**Yates Petroleum Corporation**

Re: Archimedes #1 CC:

Yates Petroleum Corporation respectfully requests to make a modification to Administrative Order SWD-814, for the Archimedes No. 1, located in Sec. 18, Township 21S, Range 24E, Eddy County, New Mexico.

Revised Proposed Configuration

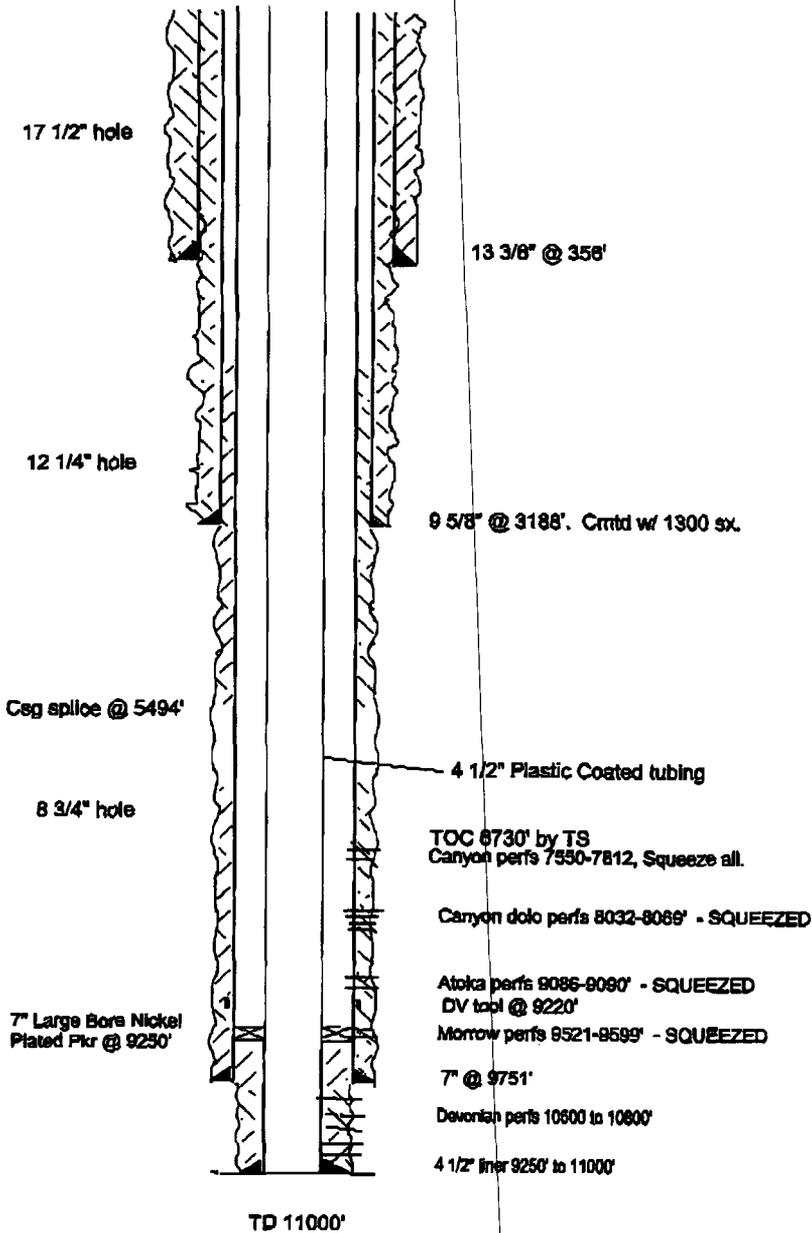
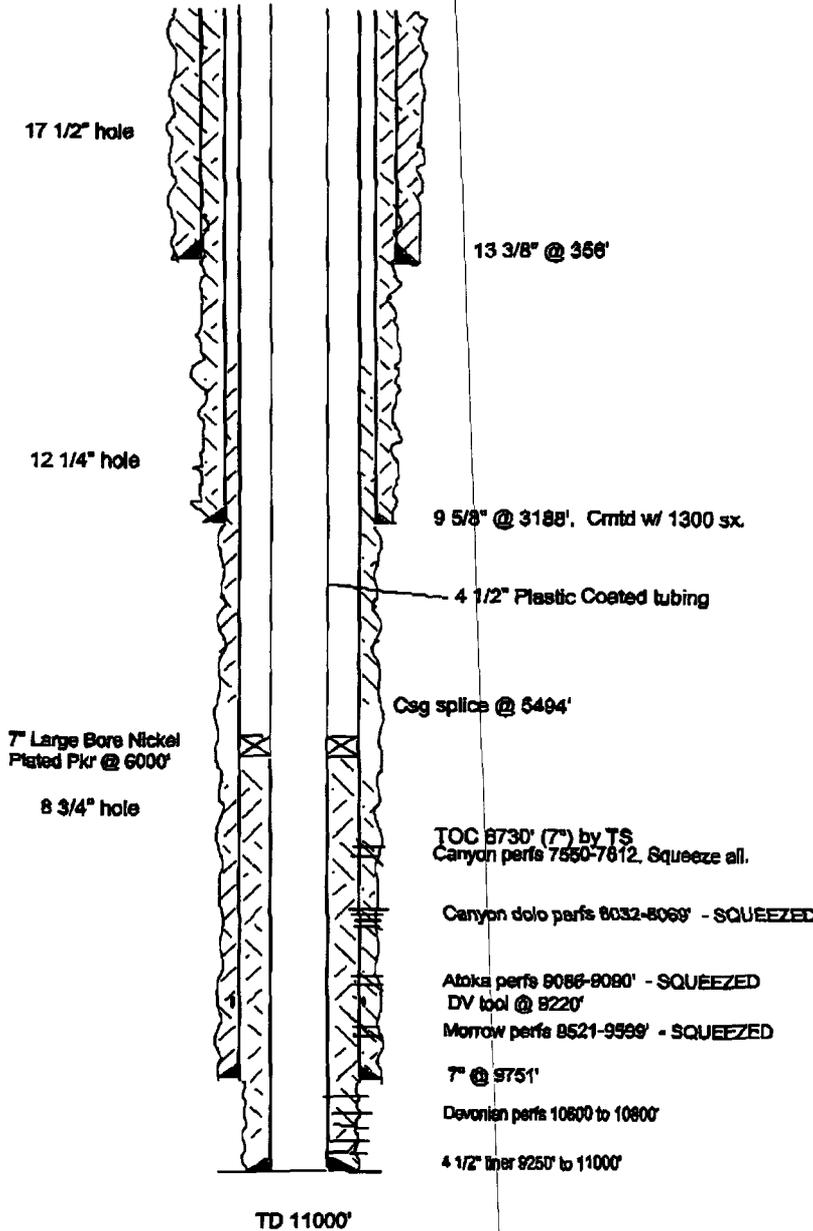
When we moved on the well to begin to prepare it for deepening to the Devonian, it was discovered that the existing 7" casing had developed a hole due to corrosion at approximately 6700'. We have repaired the hole and returned the casing to its original ID. Other perforated intervals have been squeezed. The casing has been tested to 600 psi and found to have integrity.

Our original plans were to set a 4½" liner from the planned TD of 11000' to about 9250'. We would perforate the liner in the Devonian, then run 4½" plastic coated tubing to the top of the liner.

Due to the problems with the 7" casing at approximately 6700', we would now prefer to bring the liner top to approximately 6000'. This would serve to isolate the questionable casing and all squeezed perforations above the injection interval. Plastic coated 4½" tubing will be run to the top of the liner. A diagram of the proposed installation is included with this letter.
